# Amendment

Re: Amendment #1  
Exterior Signage Project  
VA Project #636A6-12-101

AMENDMENT #1	4/22/13	CONSULTANTS:	ARCHITECT/ENGINEERS:	Drawing Title	Project Title	Project Number
			21 Delta Engineers	SIGNAGE DETAILS	EXTERIOR SIGNAGE	636A6-12-101
			21 Delta Engineers, LLC 3824 North 108th Street Omaha, Nebraska 68164 PH: (402) 496-4115 Fax: (402) 493-2744		Location	Building Number
					DES MOINES VA MEDICAL CENTER	
					Date	Drawing Number
					FEBRUARY 22, 2013	AS-2
					Checked	Dwg. 3 of 19
					PJM	QL

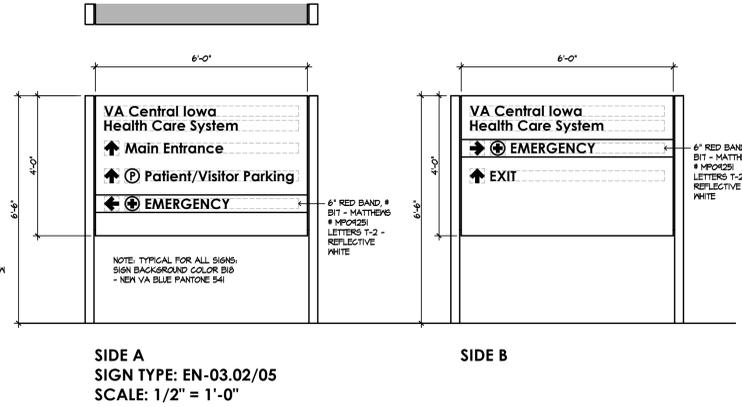
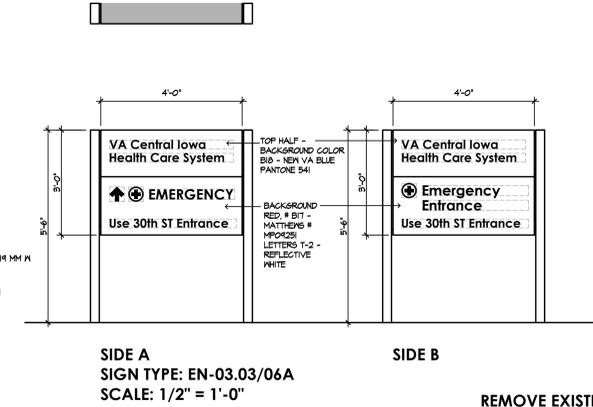
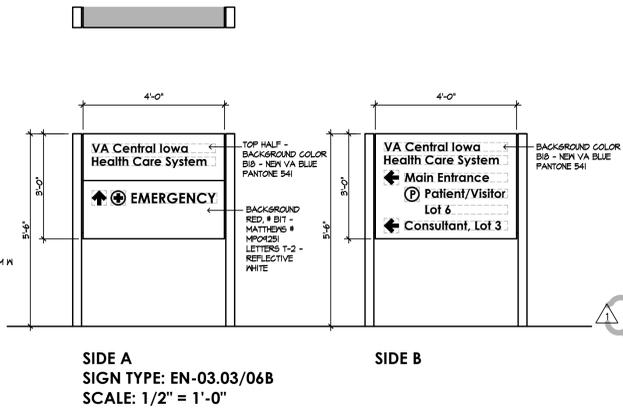
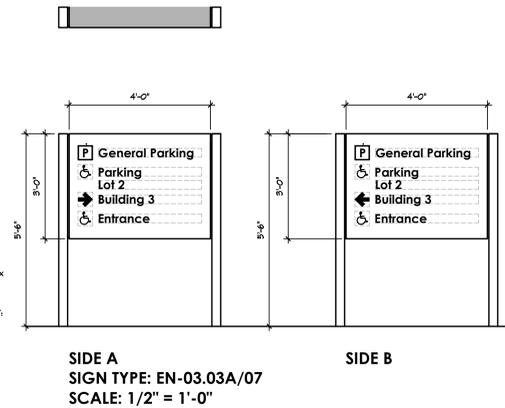
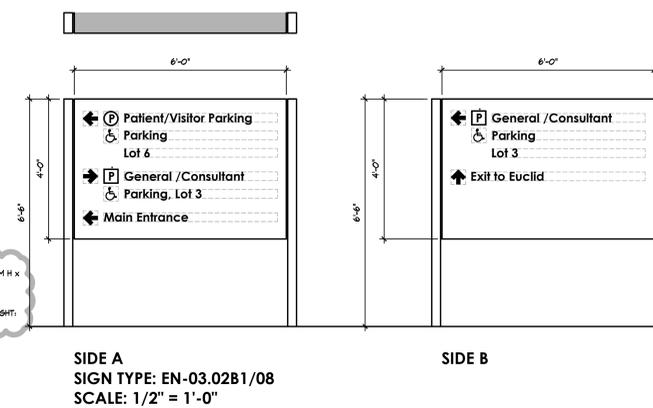
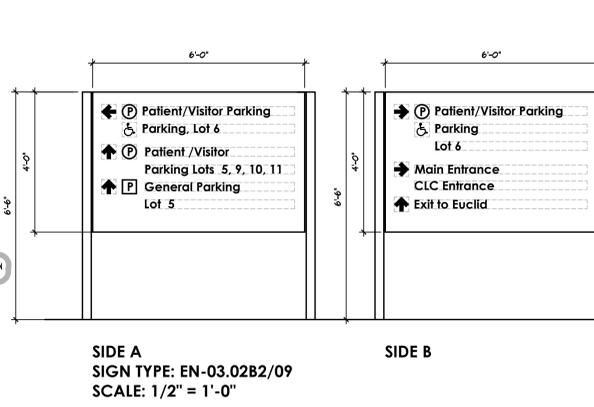
**Item 1: Refer to Drawing Sheet AS-2:**

Modify this sheet as shown in the attached in order to correct several dimension conflicts and metric equivalents.
